Browns Ferry Nuclear Plant, Units 1, 2, and 3  
Renewed Facility Operating License Nos. DPR-33, DPR-52, and DPR-68  
NRC Docket Nos. 50-259, 50-260, and 50-296

Subject: **Response to NRC Request for Additional Information Related to License Amendment Request for Adding New Specifications to Technical Specification 3.3.8.3 (BFN-TS-486) (CAC Nos. MF6738, MF6739, and MF6740) - Letter 3**

##### **TVA Responses to NRC Request for Additional Information: Set 3**

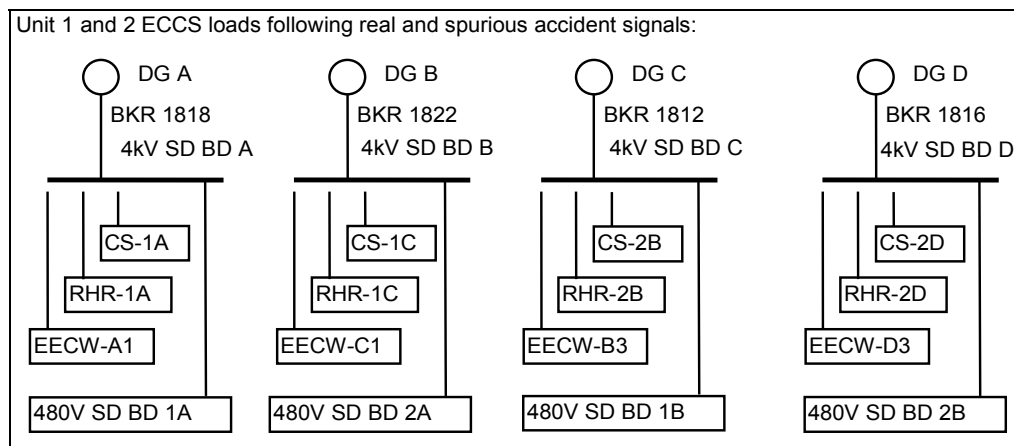
*Assuming loss-of-offsite power event, provide the latest summary of loadings of all eight emergency diesel generators (EDGs) with the PPL, for first 24 hours duration, assuming:*

- a. LOCA in Unit 1, followed by spurious accident in Unit 2;
- b. Spurious accident in Unit 1, followed by LOCA in Unit 2;
- c. LOCA in Unit 1 and loss of an EDG; and,
- d. LOCA in Unit 2 and loss of an EDG.

*Only worst case loading combinations from a or b and from c or d may be provided.*

With an accident signal present in both Units 1 and 2 (one real and one spurious), the ECCS Preferred Pump Logic (PPL) will dedicate the Division I RHR pumps 1A and 1C to Unit 1 and Division II RHR pumps 2B and 2D to Unit 2. The Division I Core Spray pumps 1A and 1C are dedicated to Unit 1, while the Division II Core Spray pumps 2B and 2D are dedicated to Unit 2. These are considered the preferred pumps. The non-preferred pumps, Unit 1 Division II and Unit 2 Division I, are tripped if running and are blocked from automatically starting.

The Diesel Load Study for Units 1 and 2 has evaluated a Unit 1 LOCA with a spurious accident signal in Unit 2. The Units 1 and 2 ECCS loads that are started on the onsite Diesel Generators are the same for a LOCA in Unit 1 followed by a spurious accident signal in Unit 2, or for a spurious accident signal in Unit 1 followed by a LOCA in Unit 2. Therefore, the Diesel Generator loading for the scenarios in EEEB RAI 3 Cases a and b are the same. Unit 3 is assumed to be in a Loss of Offsite Power (LOOP) event as evaluated in the Diesel Load Study for Unit 3. For Units 1 and 2, the LOCA and spurious accident signal would

result in the automatic starting of the ECCS pumps. The 4kV RHR pumps, Core Spray pumps and RHRSW pumps aligned for EECW would automatically start and represent the major loads on the Unit 1/2 Diesel Generators. On Unit 3, only the 4kV RHRSW pumps aligned for EECW would automatically start and represent the major loads on the Unit 3 Diesel Generators. After the large 4kV ECCS pumps are started, the 480V loads necessary for safe shutdown are automatically energized.

Diesel Generator A transient loadings are slightly over the 2850 kW rating for the first three minutes. This assumes the worst case random loads including the control bay elevator are running. This transient overload condition has been evaluated as acceptable in the Diesel Load Study for Unit 1 and 2.
